# Access Compliance Report

## Public Rights-of-Way

### (Curb Ramps)

Intersection ID: 3160	Main Street: BASKERVILLE_AV	Cross Street: CHISWELL_CT	Location: SW
ADA ID: CEB1E1BCC781	Ramp Type: Perp	Initial Pass/Fail: Fail	Overall Compliance: No
Severity Score: 1.25			
Codes/Mitigation Info/Possible Solution		Field Measurements/Component Compliance

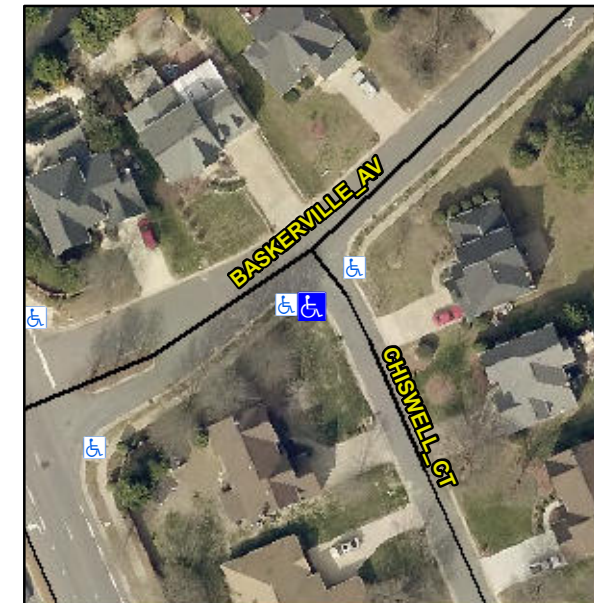
**Not Found, R304.5.3**

Compliance	Description	Data	Compliance	Description	Data
N/A	Ramp Length (in)	46.0	Yes	Ramp Slope (%)	6.4
Yes	Ramp Width (in)	60.0	No	Ramp XSlope (%)	2.5
N/A	Flare Type LT	N/A	N/A	Flare Type RT	N/A
N/A	Flare Slope LT (%)	N/A	N/A	Flare Slope RT (%)	N/A
N/A	Flare Traversable LT?	N/A	N/A	Flare Traversable RT?	N/A
N/A	Landing Length (in)	N/A	N/A	DWS Provided?	N/A
N/A	Landing Width (in)	N/A	N/A	DWS Contrast?	N/A
N/A	Landing Slope (%)	N/A	N/A	DWS Length (in)	N/A
N/A	Landing X Slope (%)	N/A	N/A	DWS Full Width?	N/A
N/A	Landing Curb? (Y/N)	N/A	N/A	DWS Offset (in)	N/A
N/A	Shared Landing?	N/A			
N/A	Gutter Ponding?	N/A	N/A	Gutter Slope (%)	N/A
N/A	Gutter Lip Ht (in)	N/A	N/A	Gutter X Slope (%)	N/A
N/A	Painted X Walk1?	No	N/A	Painted X Walk2?	N/A
	X Walk 1 Direction	To E		X Walk 2 Direction	N/A
N/A	X Walk 1 Width (in)	N/A	N/A	X Walk 2 Width (in)	N/A
	X Walk 1 Slope (%)	4.1		X Walk 2 Slope (%)	N/A
	X Walk 1 X Slope (%)	3.3		X Walk 2 X Slope (%)	N/A

**Remove & Replace Entire Ramp.**
